COX CREEK BRIDGE

DEPARTMENT OF HIGHWAYS ONTARIO BRIDGE DIVISION			
69 P. 20			
COX CREEK BRIDGE 7.9 miles west of Hwy. 7			
KING'S HIGHWAY No. 86		DIST. No. 3	
CO. Waterloo		TWP. Woolwich	
LOT 1 & 126		CON. 1 & G.C.T.	
GENERAL LAYOUT			
APPROVED		SITE No. 33-60 W.P. No. 135-6600	
DESIGN	CHECK	CONTRACT	No.
DRAWING	CHECK	DRAWING	No.
DATE	JAN '70	LOADING	HS 20d.3
DRAWING No. 0-6706-1

Re: FOUNDATION INVESTIGATION REPORT
By: Peto Associates Limited --
Cox Creek Bridge, Highway 86
Elmira, Ont. -- District No. 3
W.P. 135-66-00 33-60

FOUNDATION INVESTIGATION
COX CREEK BRIDGE HIGHWAY 86
ELMIRA, ONTARIO

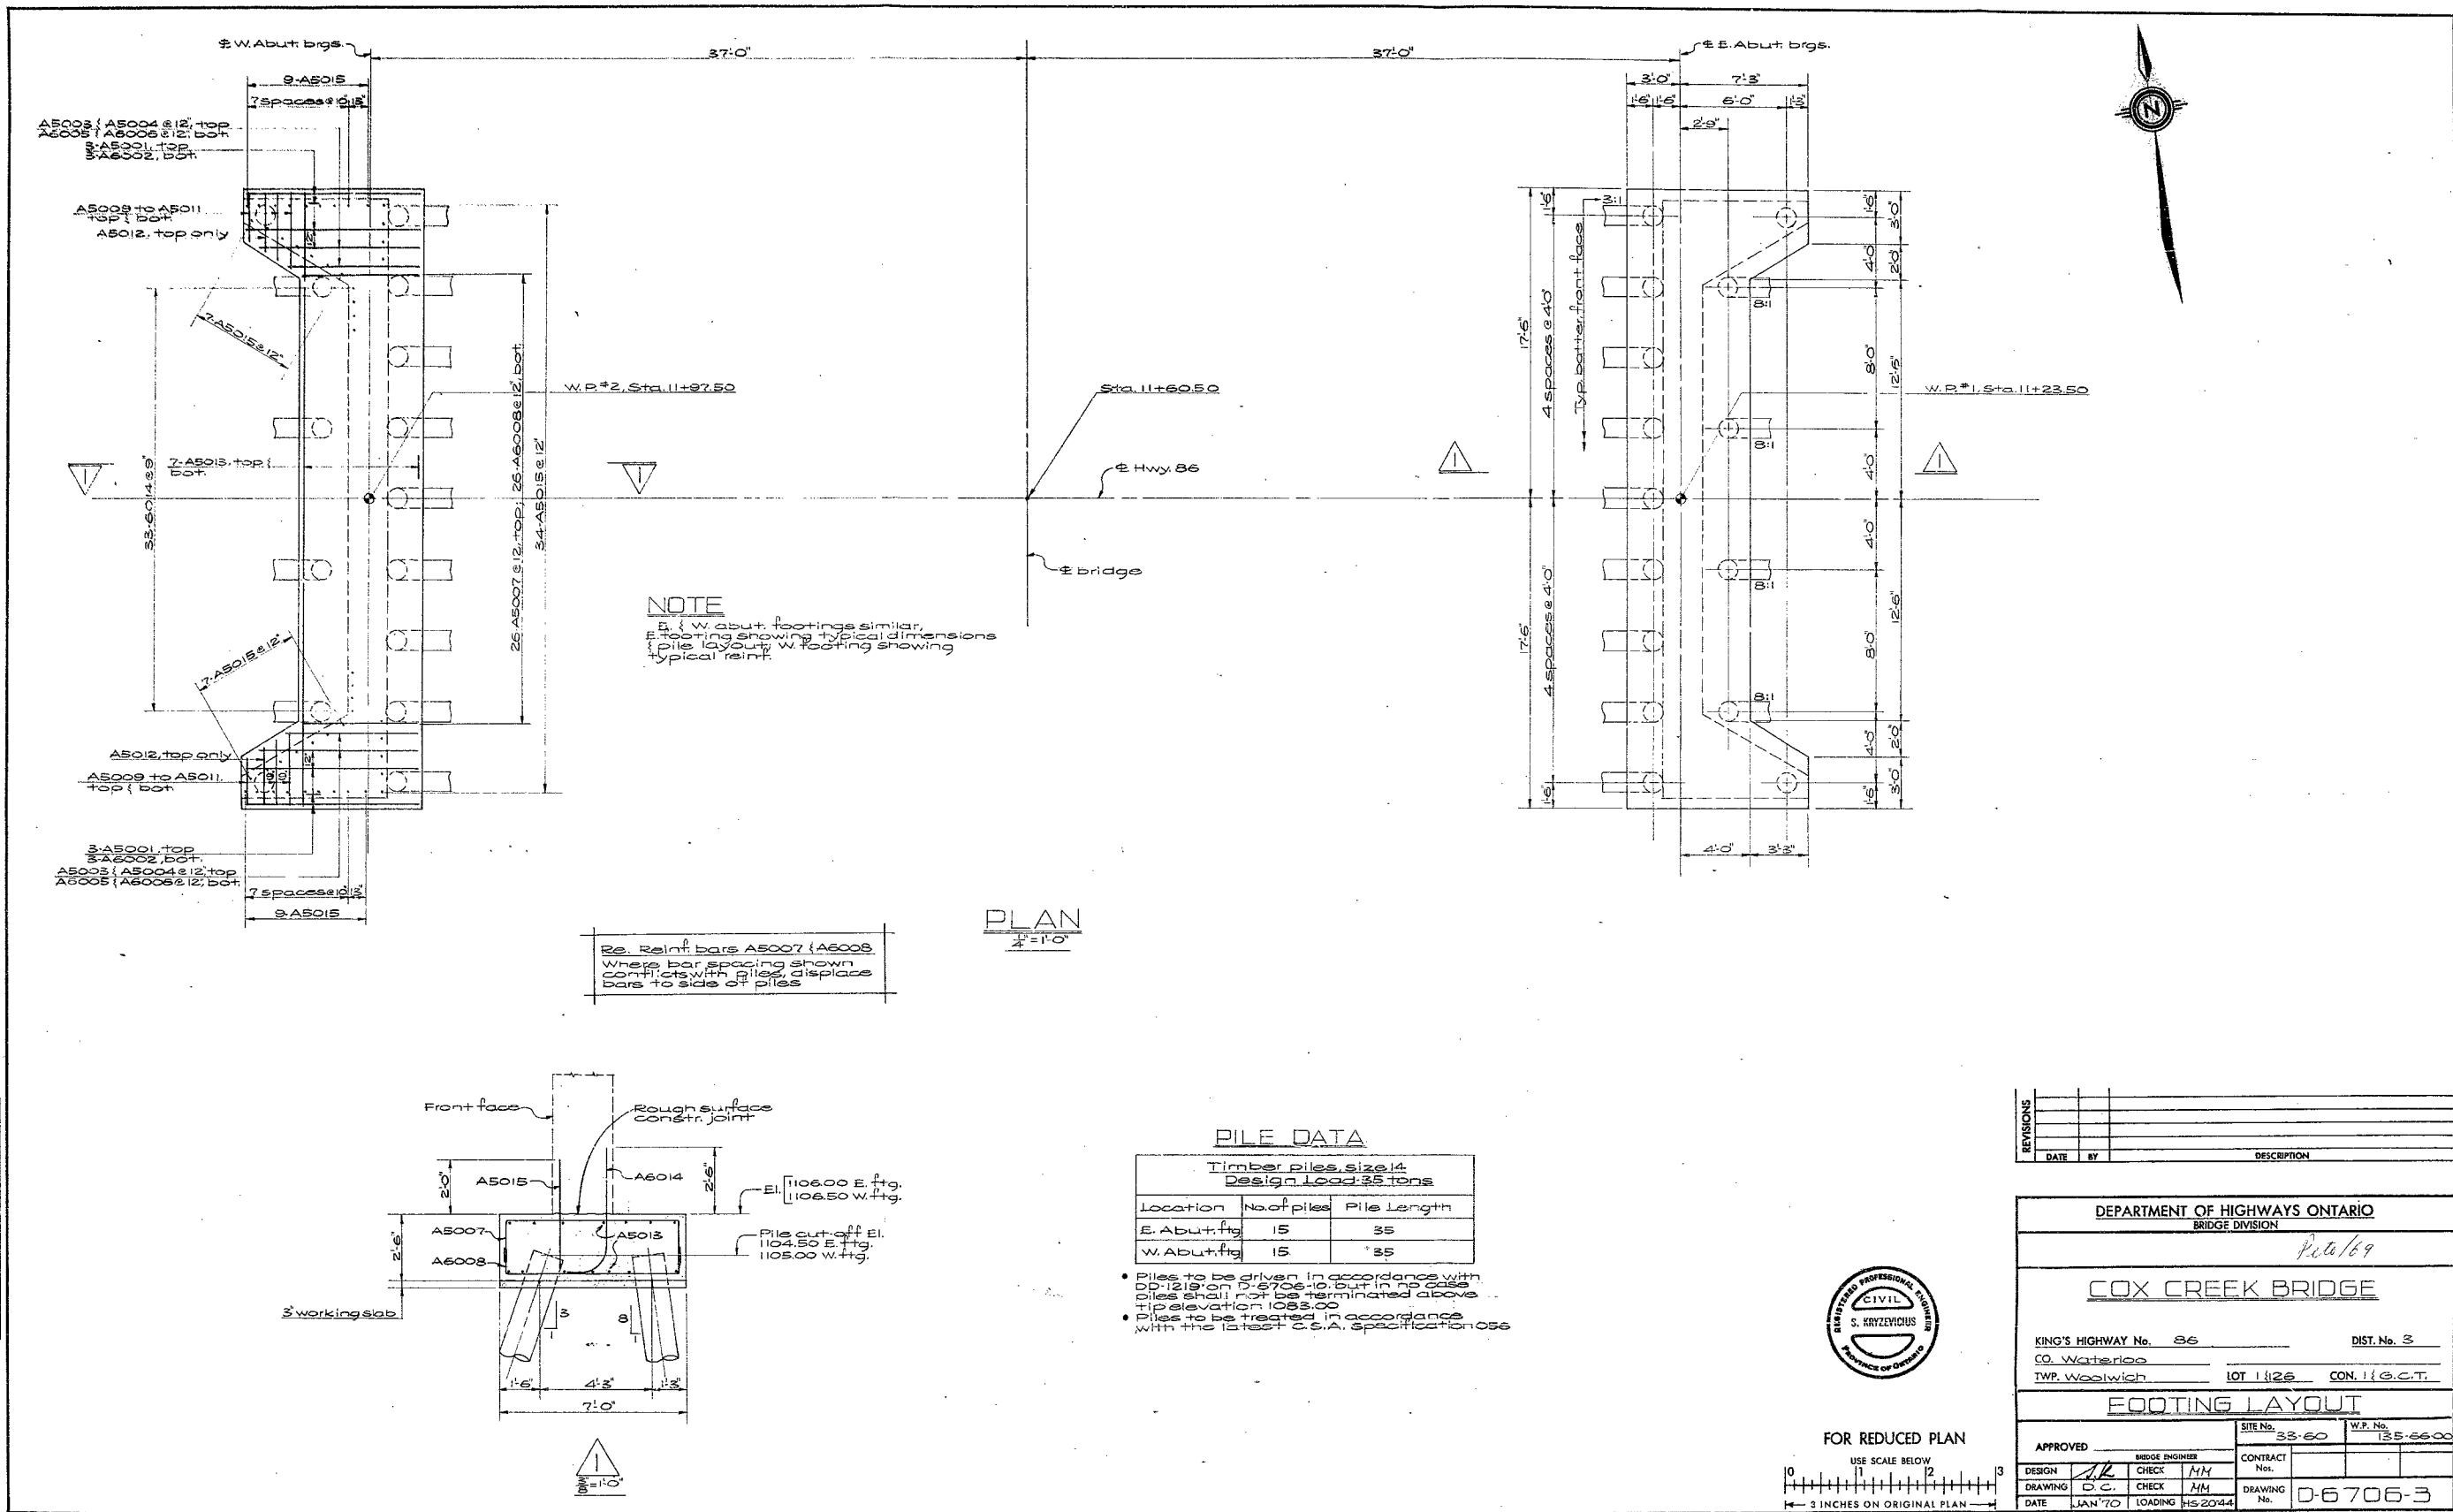
NOW THE CONTRACTOR IS
QUESTIONING, WHETHER TIMBER
PILES CAN BE DRIVEN EFFECTIVELY
WOULD YOU PLEASE DISCUSS THIS
WITH ME PRIOR TO ADVISING
AL HALLIN OF OUR THINKING.

PILES HAVE TO GO DOWN TO EL. 10802
FOR SLOUR PROTECTION.

CONSULTANT'S PREDICTIONS FOR 25-30" PILES:
REFUSAL AROUND EL. 1083 TO 1077.

DESIGN CALLS FOR SAFE BEARING OF
35" PILE (TIMBER PILE SIZE 14)

LENGTH 35 FT - TIP EL 1070.0

MINIMUM PENETRATION DEPTH 1083.0
FOR HYDROLOGICAL REASONS.

A CHANGE OF PILE LENGTH FROM 35 FT
TO 41 FT WAS MADE, BEARING UNCHANGED.

DRIVING IN THE FIELD SOMEWHAT DIFFICULT
PILES ARE DRIVEN 25 TO 30 FT I.E TO
TIP ELEVATIONS 1080 AND 1075, RESPECTIVELY.
